Access Compliance Report Public Rights-of-Way (Pedestrian Signals)

Main Street: **ANTONIO_PKWY** Cross Street: **N/A** Location: **SW**

ADA ID: **SGRK211202125904** Signal Type: **One Push Button-Non APS** Overall Compliance: **No** Severity Scores: **BTN 1: 10** **BTN 2: N/A** **No BTN: N/A**

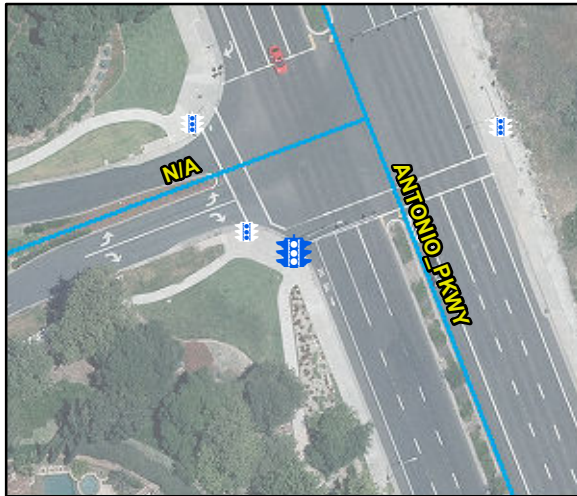
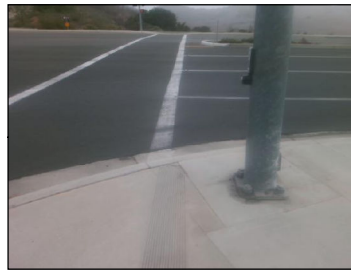
Possible Solutions: Replace Signal Push Button With APS Button.

OC Std/PROW: MUTCD 4e.08
